19 August 2024 Joclyn Marshall lai-lais/richtersveld transfrontier **EcoRoute Environmental Consultancy** P.O.Box 1252, Sedgefield addo elephant 6573 agulhas Per email: admin@ecoroute.co.za Western Cape Department of Environmental Affairs & Development augrabies falls Planning Reference No.: 16/3/3/6/7/1/D2/19/0099/24 bontebok **RE: PROPOSED RESIDENTIAL DWELLING AND GUEST ACCOMODATION UNITS ON ERF 301, HOEKWIL, WILDERNESS** camdeboo HEIGHTS, GEORGE MUNICIPALITY, WESTERN CAPE. **BASIC ASSESSMENT, PRE-APPLICATION PHASE** golden gate highlands Erf 301, Whites Road, Hoekwil, Wilderness Heights, falls within the Garden Route National Park (GRNP) Buffer Zone and within the karoo Coastal Protection Zone (CPZ). Achieving a conservation outcome on this property is important to SANParks. kgalagadi transfrontier A non-perennial river runs through the property along the property's knysna eastern boundary from north to south (Fig. 1). A second north to south running non-perennial river borders the property outside to the west kruger (Fig. 5). This is situated between 20 - 40m in places away from the property boundary. Critical Biodiversity Areas (CBA) are mapped as extending across the entire p

Figure 3: Site Development Plan for Erf 301 Hoekwil in Wilderness.

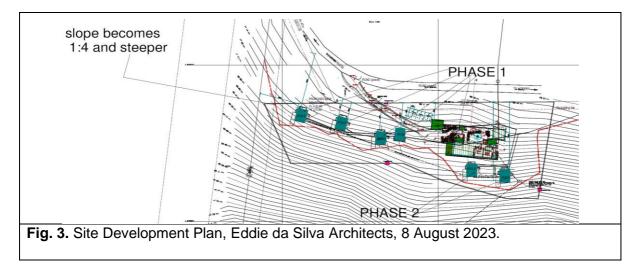
The Environmental Assessment Practitioner (EAP) argues that as the front half of the dwellings will be raised on columns off the ground, <u>disturbance areas will be less than the footprint areas.</u> SANParks disagrees with this statement as regardless of levelling only occurring in one section, the building will still "shadow out" the entire area and occupy the entire footprint space in the landscape permanently. <u>Disturbance areas may in fact be greater than the total stated footprint area of 1638m<sup>2</sup></u>. Area calculations appear not to have been included for embankments and retaining structures which will be required to stabilize the access road, driveway, parking, and building platforms, nor for the artificially constructed stormwater swale, and for developing on steep slope sections. Earthworks, soil movements and storage have not been factored in. A working area space of 2m around dwellings is not considered adequate for working on this challenging site.

SANParks does not support the construction of the six pods, some of which appear to be situated on the 25-90 degree/ 1:4 and steeper slope areas or bordering these. SANParks believes that these pods will fragment the landscape and will set a dangerous precedent for neighboring properties, who will follow suit, resulting in cumulative impacts.

<b>Fig. 10:</b> Slopes on property showing 25-90 degree slopes in sections. George Municipality GIS viewer, August 2024.	<b>Fig. 11:</b> Biodiversity Corridor Mapping. George Municipality GIS viewer. George Municipality GIS viewer, August 2024.

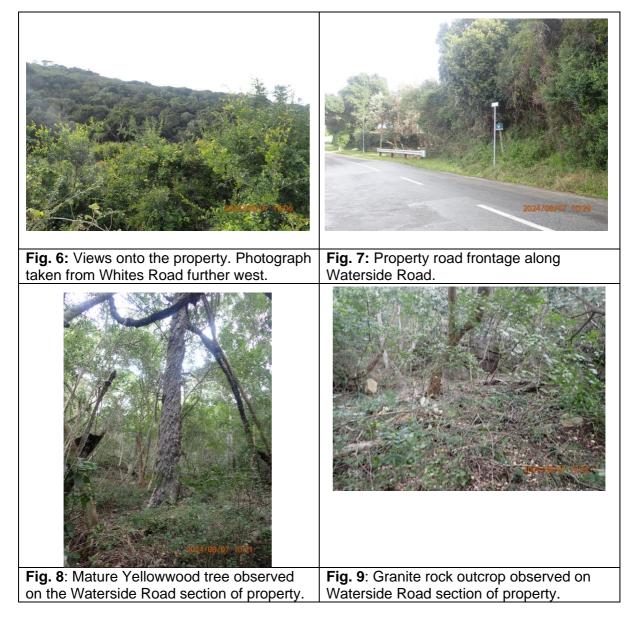
The majority of the property is mapped as comprising of 25-90 degree slopes (Fig. 10). Although it is noted that the dwellings are planned to be sited in the less steep site areas, the steep slopes below have the potential to be impacted by vegetation removal, soil erosion, and water runoff. Open areas under the dwellings will require stabilisation, as vegetation is unlikely to grow under structures, due to low light conditions and the south-facing slopes.

SANParks will support the rezoning of the property from Agriculture II to Open Space III and the tourism consent use. The property has valuable linkages into biodiversity corridors (**Fig. 11**) and is important for landscape functionality and connectivity in the region.
